RE: Johnson/PLN210061

Re: Johnson Hal W Jr. & Allison H; File No. PLN210061; May 28, 2025 Monterey County Planning Commission, Agenda Item No. 2.

Re: Response to Peer Review Comments for  
Proposed Development at 226 Highway 1  
Carmel Highlands, California  
Monterey County APN 241-182-003

SUBJECT:           **RESPONSE TO PEER REVIEW COMMENTS**  
Proposed Single Family Residence  
226 Highway 1, Carmel, California (Previously 244 #3 Highway 1)  
APN: 241-182-003-000

**PLANTING PLAN**  
0 8' 16' 32'  
SCALE: 1/16" = 1'-0"

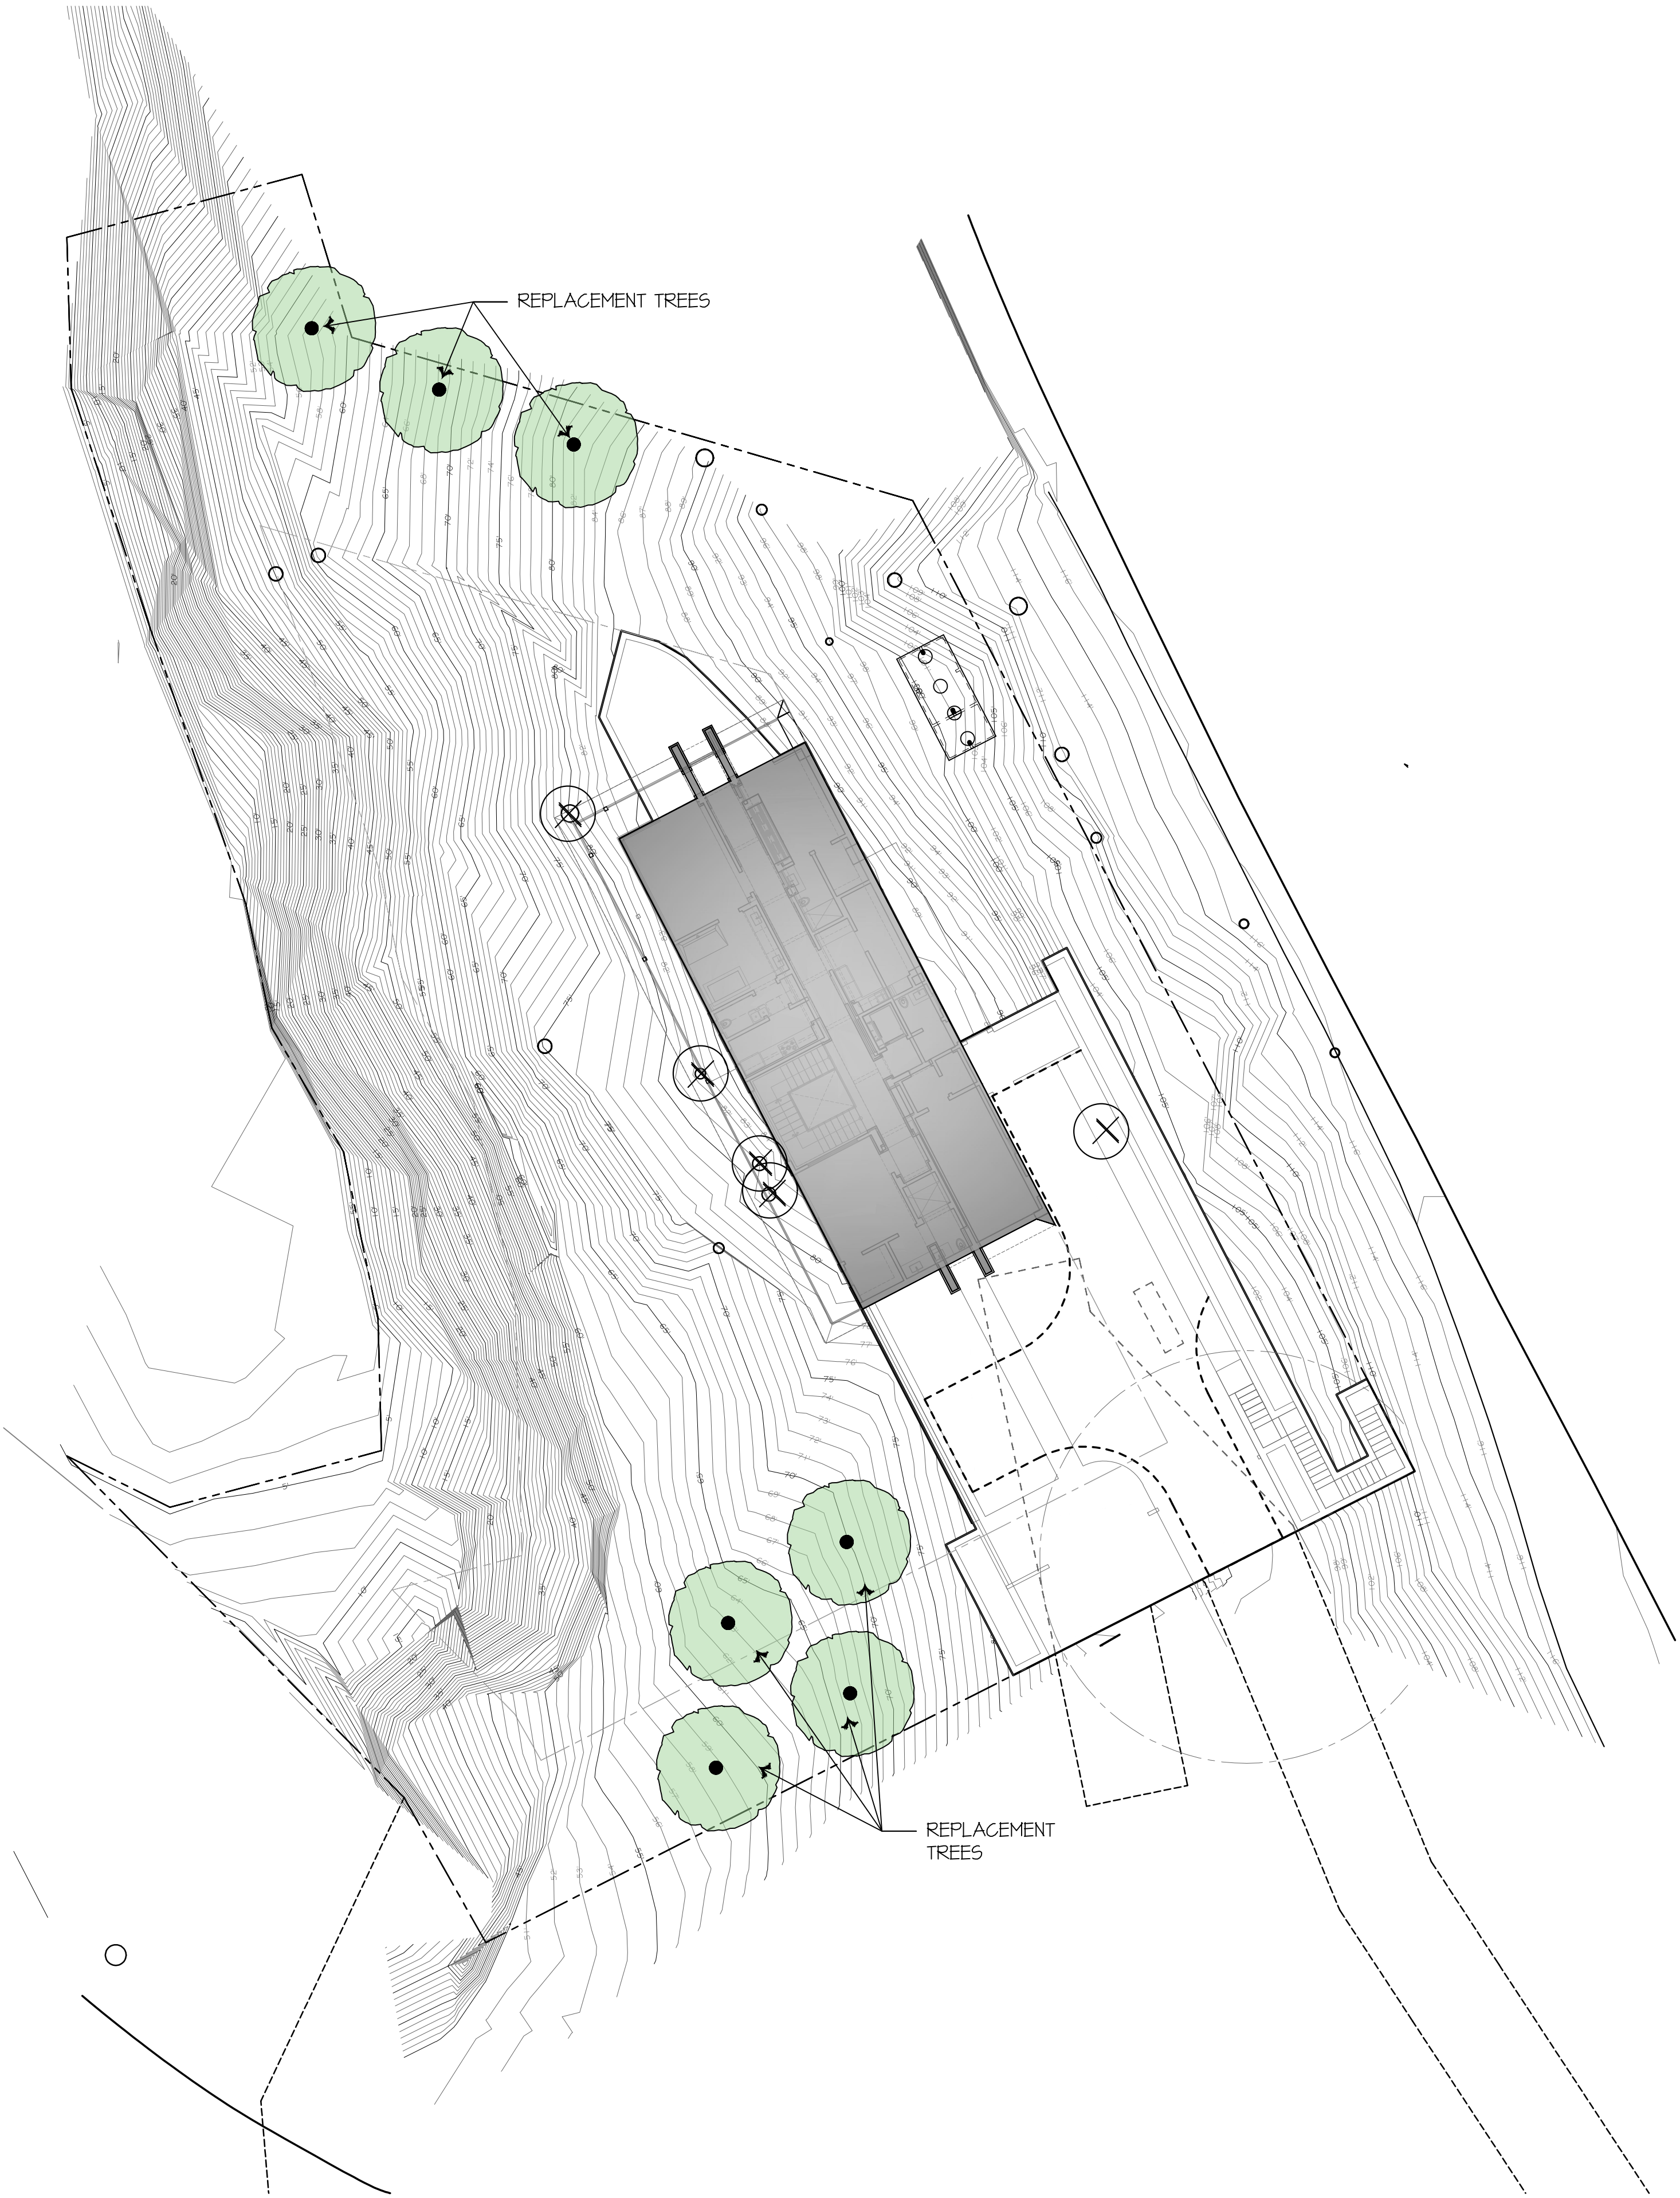
In terms of replacement trees, we had asked the Project applicant to provide a copy of the Landscape Plan shown on Sheet A1.1. The Project plans currently require four replacement trees. Sheet A1.1 showed three replacement trees on the northern elevation of the Project residence. On May 27, 2025 the applicant's attorney provided a copy of the Landscape Plan dated May 23, 2025 that included the three trees along the north plus four new trees on the south that would block coastal views from Owner's residence. (See Exhibit B.) The existing trees proposed for removal do not block such views. We raised these concerns with the applicant's attorney who indicated that the architect may have misunderstood the request and indicated a willingness to work with the Owner on the location of the replacement trees. Along those lines, if the Project were to be approved, we ask that a condition be imposed to require Owner's consent to the location of the replacement trees.

## Photographs

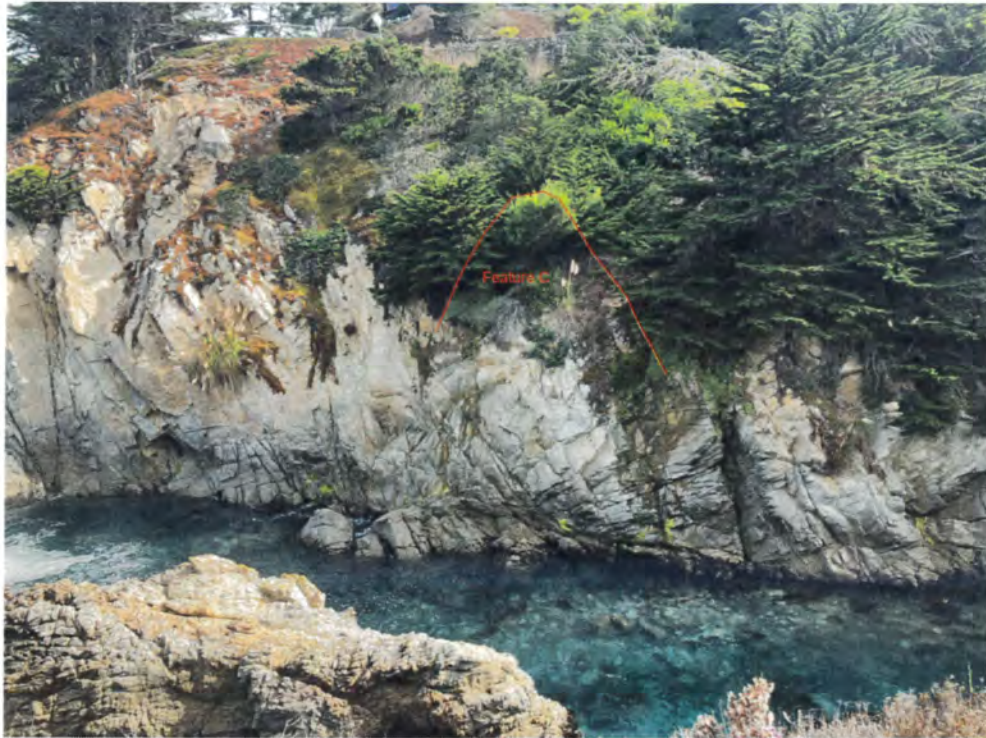
Easton Geology Response: Feature "B", as delineated by the reviewer, is located below the joint-bounded scarp mapped by our firm. Formation of the joint-bounded scarp appears to be the

Feature B – Potential Wedge Failure.

result of a wedge failure within the weathered granite on the upper bluff. We measured two adversely dipping joint sets in this area, and their resulting line of intersection (the axis of sliding) trends 228AZ and plunges approximately 47 degrees to the southwest. The upslope trend of the axis of sliding passes well north of the proposed residence. Current revised plans for the project depict the proposed residence about 30 feet from the left margin of the mapped wedge failure scarp depicted on Plate 1 of our report and is at least 40 feet from the axis of sliding. The footprint of the proposed residence and its foundation will not be affected by potential enlargement of this slide feature. We saw no wedge failures of similar or larger size during our investigation.

**Figure 5 Project Elevation Profile**

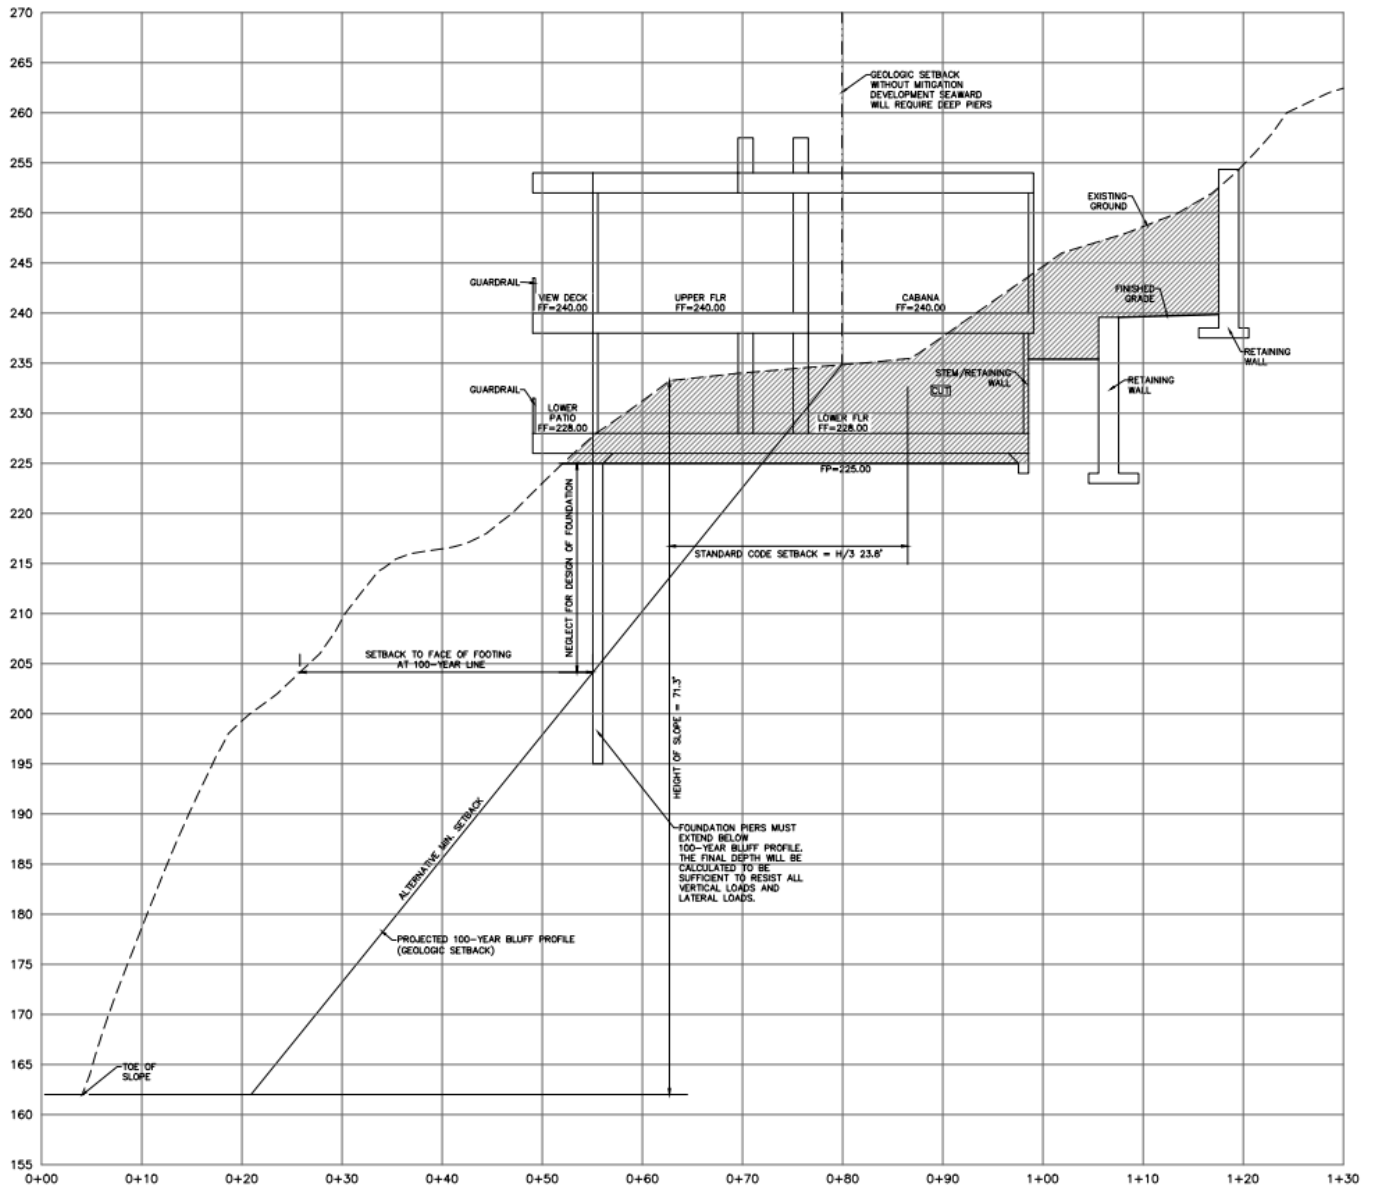
<sup>1</sup> Figure 5 (Project Elevation Profile) of the MND shows how the majority of the Project extends beyond the geologic setback line, protruding over the steep coastal cliff face. A copy of this figure is attached hereto as Exhibit A.
